**AGENDA**  
**BUILDING & STANDARDS COMMISSION**  
**Monday, June 1, 2026, 6:30 PM**

| <b>AGENDA CAPTION:</b> | Update from staff regarding the adoption and updates to the 2024 International Building Codes. |

ORDINANCE NO. \_\_\_\_\_

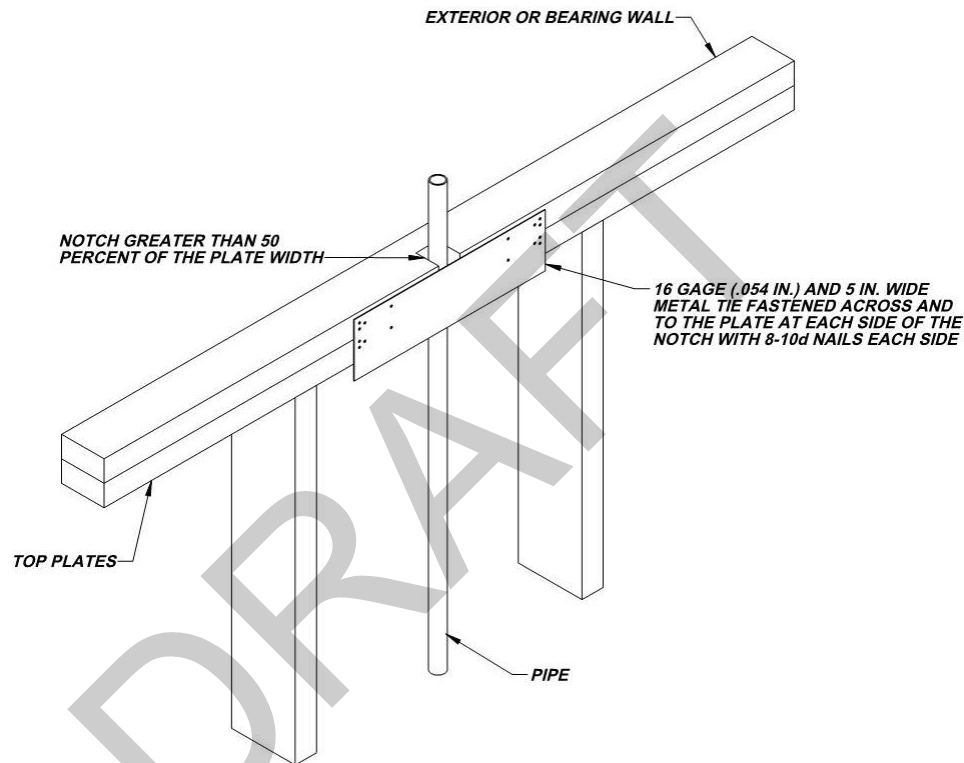
23. Section R602.6.1 is amended to read as follows:

**R602.6.1 Drilling and notching of top plate.** When piping or ductwork is placed in or partly in an exterior wall or interior load-bearing wall, necessitating cutting, drilling or notching of the top plate by more than 50 percent of its width, a galvanized metal tie not less than 0.054 inch thick (1.37 mm) (16 Ga) and 1 ½ inches (38 mm) 5 inches (127 mm) wide shall be fastened across and to the plate at each side of the opening with not less than eight 10d (0.148 inch diameter) having a minimum length of 1 ½ inches (38 mm) at each side or equivalent. Fasteners will be offset to prevent splitting of the top plate material. The metal tie must extend a minimum of 6 inches past the opening. See figure R602.6.1. {Remainder unchanged}
